This letter is in reference to Concho's Lakewood SWD #1, API 30-15-40717 and SWD Permit 1350.

APPLICATION FOR AUTHORIZATION TO INJECT

WELL NAME & NUMBER: **Lakewood SWD #1 API 30-15-40717 and SWD Permit 1350**

Amendment to SWD Application:

WELLBORE SCHEMATIC

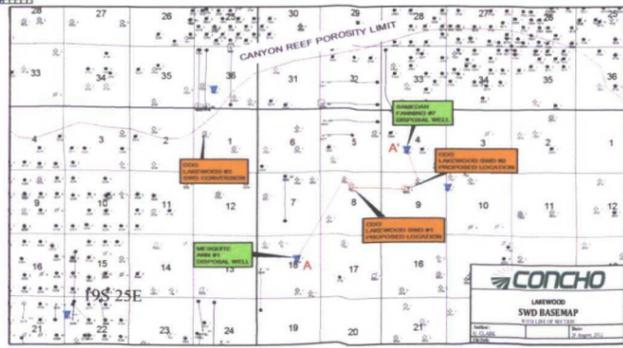
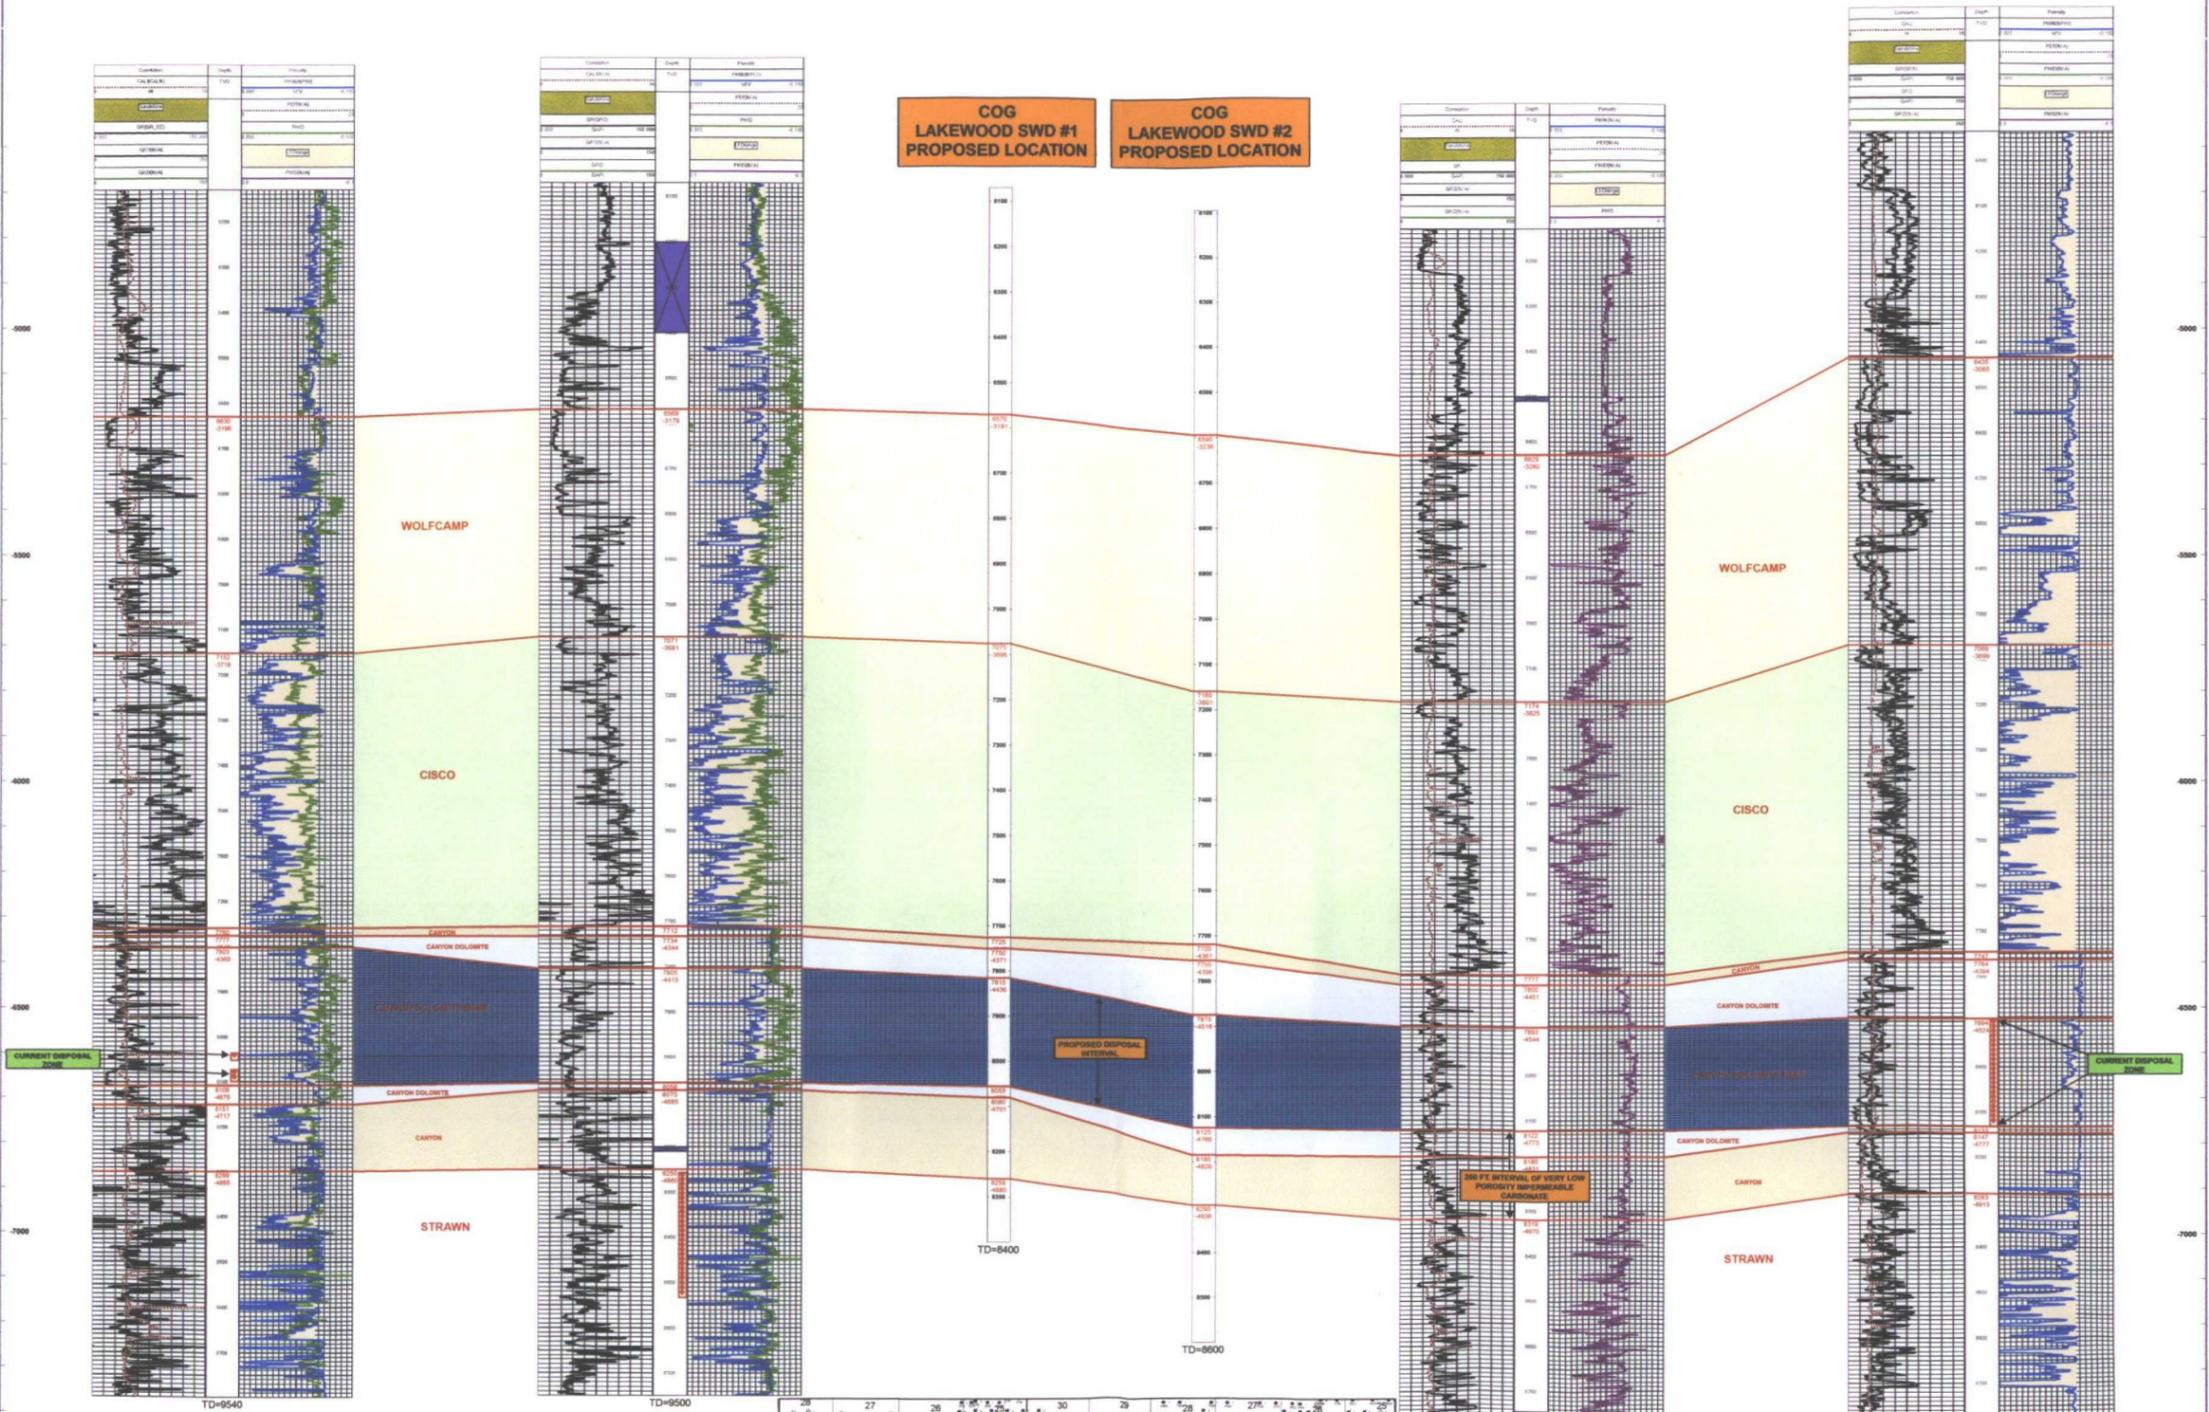
- a. A very short letter asking for the amended permit and the reasons for it.
- b. The admin order checklist
- c. The C-108 "Injection Well Data Sheet" pages (with API number, well information, etc).
- d. A bigger copy of Greg Clark's X-Section (the emailed version is illegible as to the depths)

Kanicia,
I save everything..and I found the Wellbore Diagram

7840 feet to **8084**
Interval perforated
 (Perforated or Open Hole; indicate which)
